802.3cb Proposed Text Changes for Clause 69, 73, 78, 125

William Lo
Marvell

Figure 69-2a—Architectural positioning of 2.5 Gb/s and 5 Gb/s Backplane Ethernet

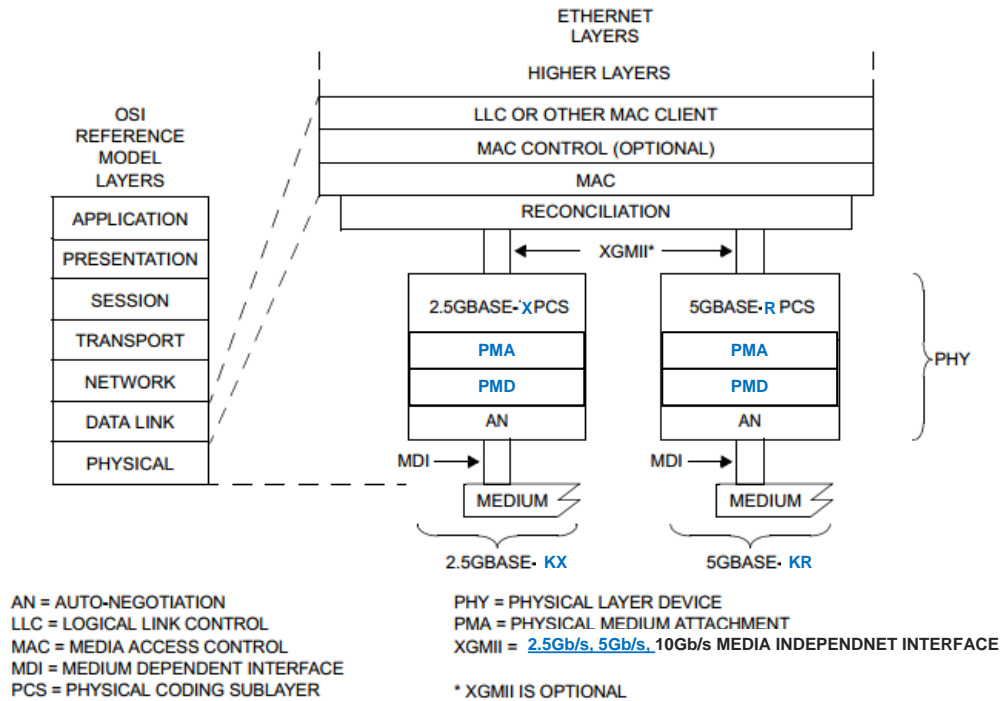
Change the first paragraph of 69.1.2 as modified by IEEE Std 802.3by-201x and insert Figure 69-2a as follows:

Backplane Ethernet couples the IEEE 802.3 MAC to a family of Physical Layers defined for operation over electrical backplanes. The relationships among Backplane Ethernet, the IEEE 802.3 MAC, and the ISO Open System Interconnection (OSI) reference model are shown in Figure 69–1, Figure 69–1a, and Figure 69–2, and [Figure 69-2a](#).

Copy figure 125-1 from 802.3bz and redraw diagram as sketched below:

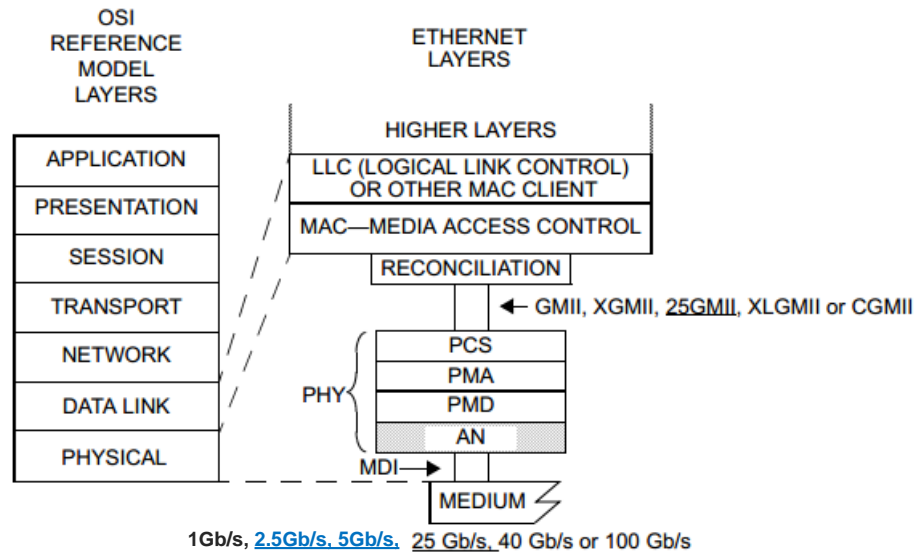
Change the first paragraph of 69.5 as modified by IEEE Std 802.3by-201x as follows:

The supplier of a protocol implementation that is claimed to conform to any part of IEEE Std 802.3, Clause 70 through Clause 74, Clause 84, Clause 91, Clause 93, Clause 94, Clause 108, Clause 111, Clause 202, Clause 203, and related annexes demonstrates compliance by completing a protocol implementation conformance statement (PICS) proforma.

Figure 125-1—Architectural positioning of 2.5 Gigabit and 5 Gigabit Ethernet

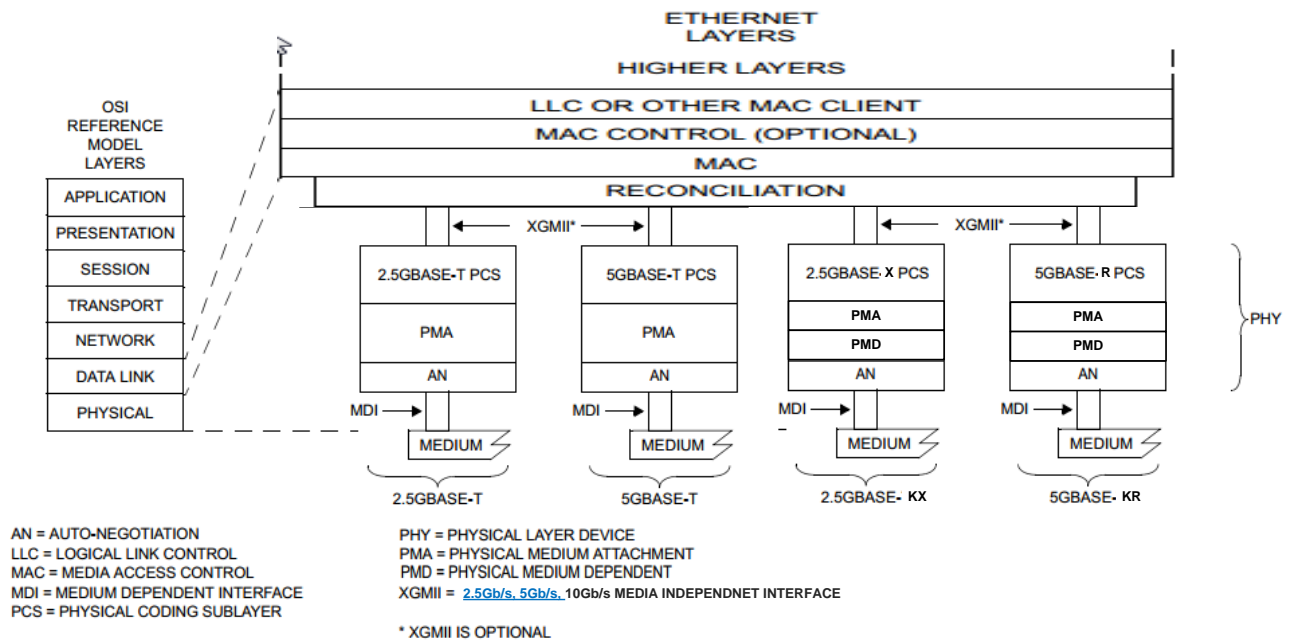
Replace Figure 125-1 with the figure below

Copy figure 125-1 from 802.3bz and redraw diagram as sketched below:
